SEWAGE DISPOSAL SYSTEM

DEPARTMENT OF HEALTH AND MENTAL HYGIENE

SUBDIVISION Wellington LOT 11 ROAD 2839 Hunt Valley Drive

SEPTIC PLAN A4J122

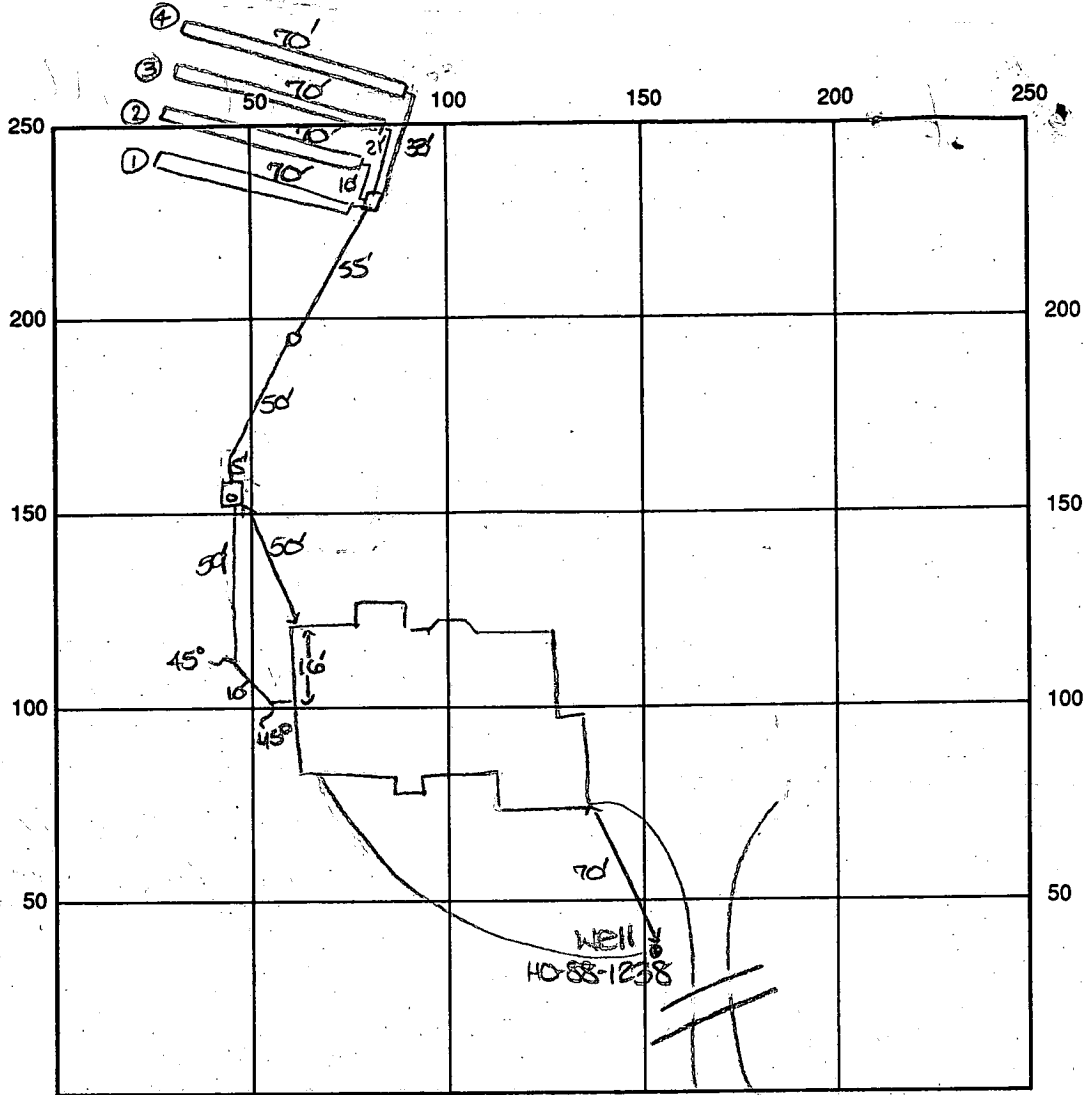
SEPTIC TANK LEVEL OK - 1500 gal CLEANOUTS one on s.t., one in line

DISTRIBUTION BOX LEVEL OK - haffle in

REMARKS: 7/25/96 OK to adjust 1st two trenches to accommodate house plumbing. DKS

7/25/96 OK to continue work. Need house connection. DKS

7/25/96 OK to cover all work. Need house connection. DKS

8/13/96 House connection made - AM

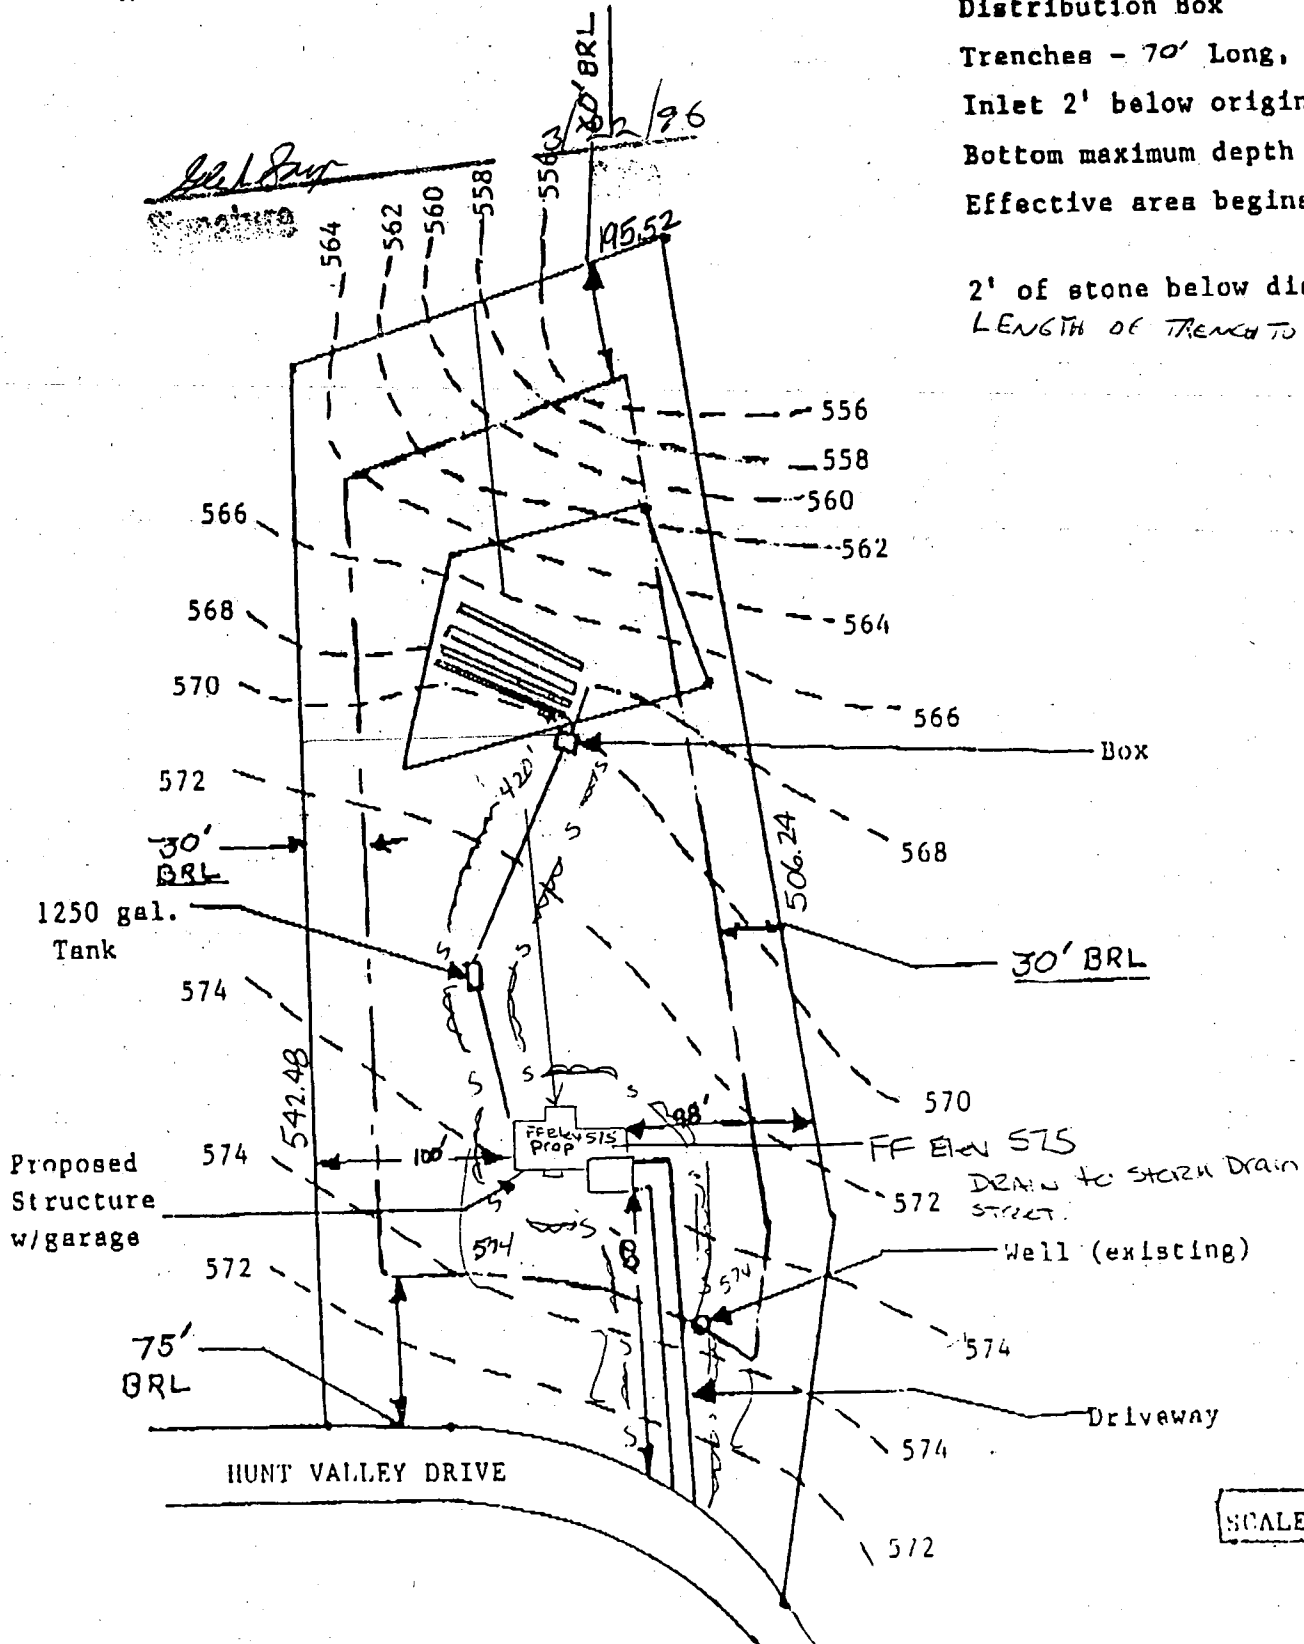
2' of stone below distribution pit
LENGTH OF TRENCH TO BE DETERMINED

SEPTIC PLAN A41122

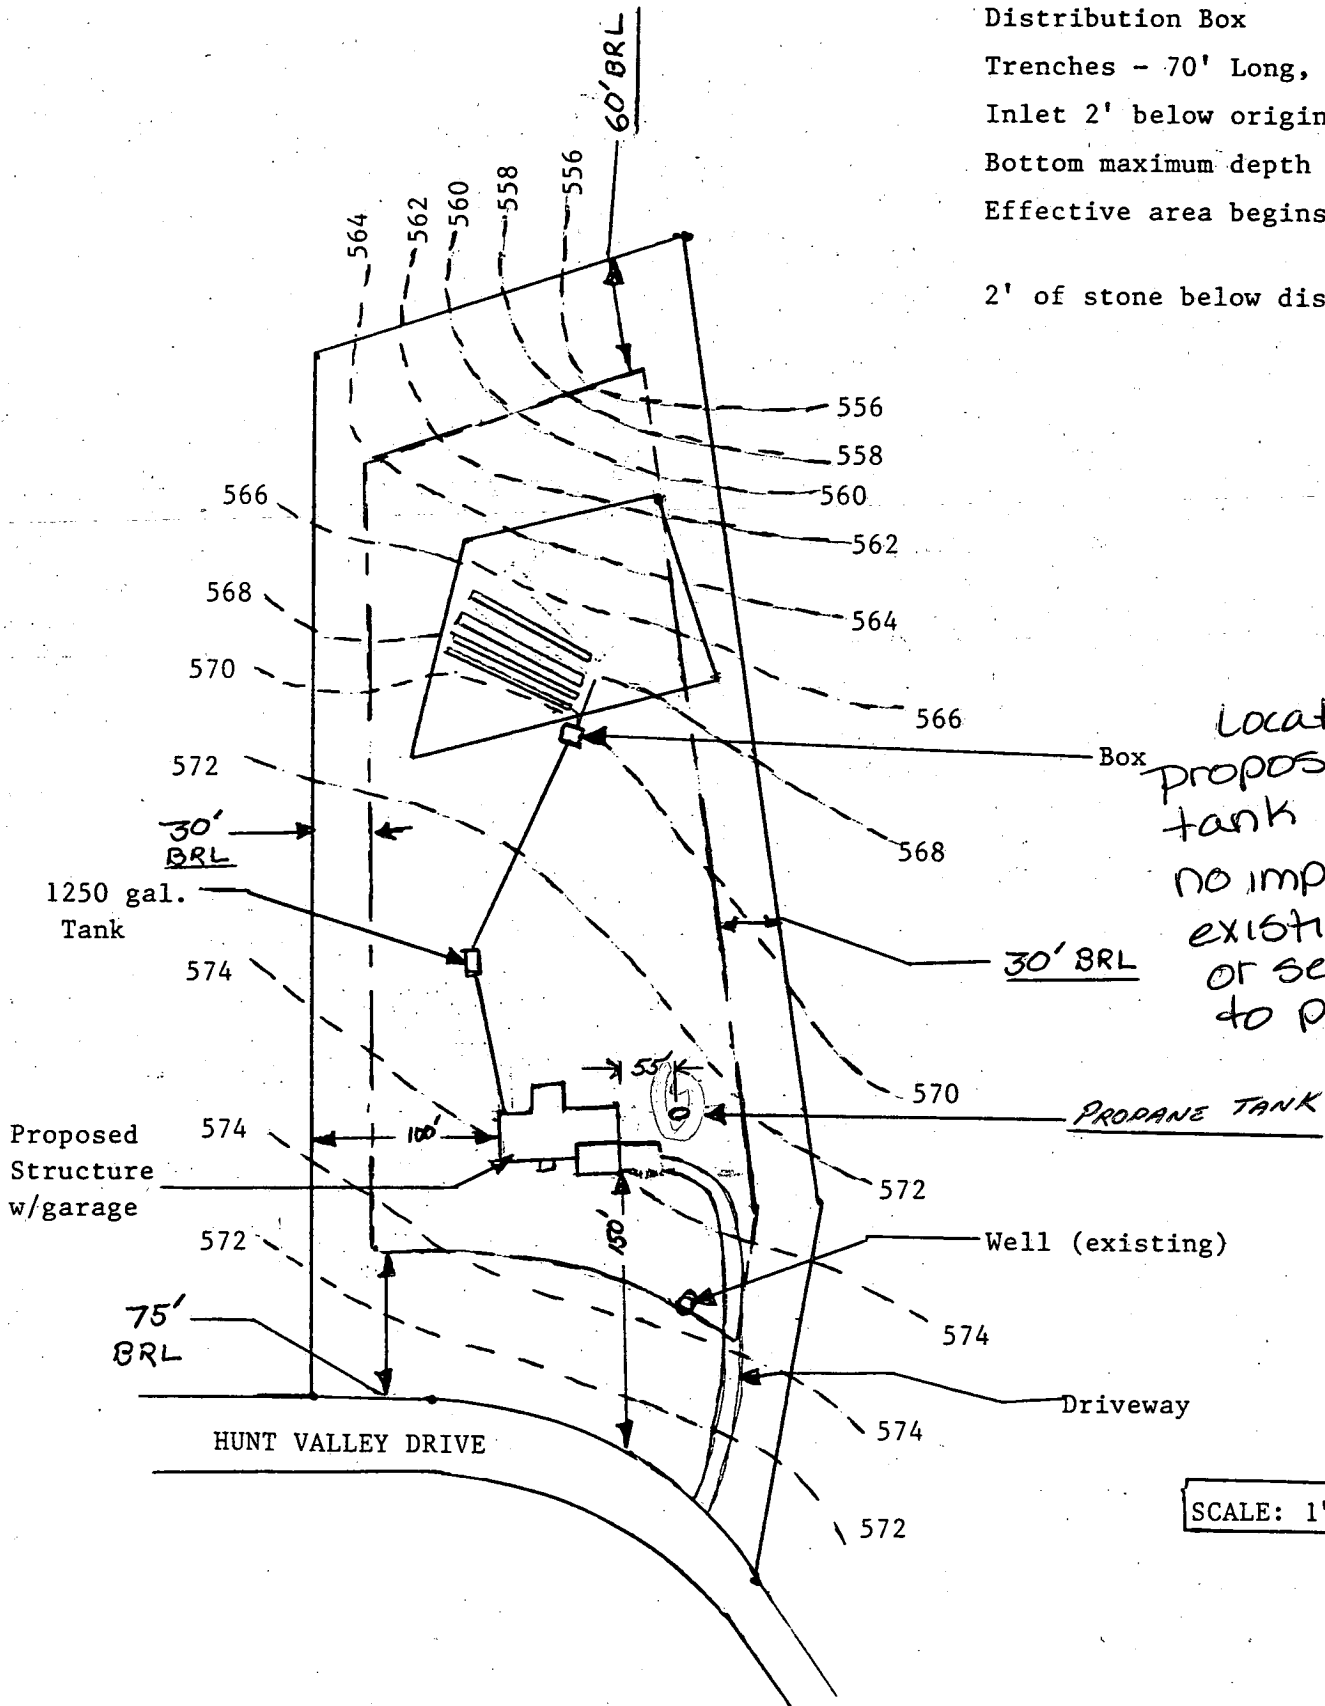
Trenches - 70' Long, 3' Wide

Inlet 2' below original grade

Bottom maximum depth 4' below grade

Effective area begins at 2' below grade

2' of stone below distribution pipe

"P16-WALK THRU"
B

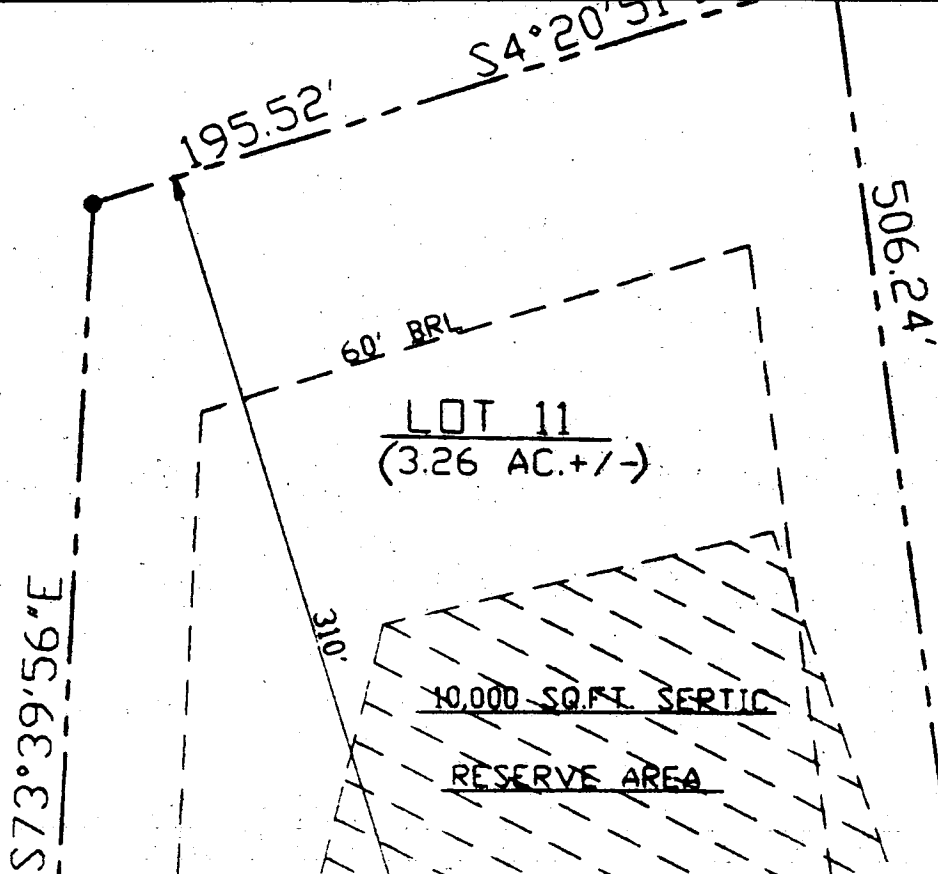
POOL - 10K AS PROPOSED
APPROX. CLEARANCE TO
WELL & SEPTIC SYSTEM
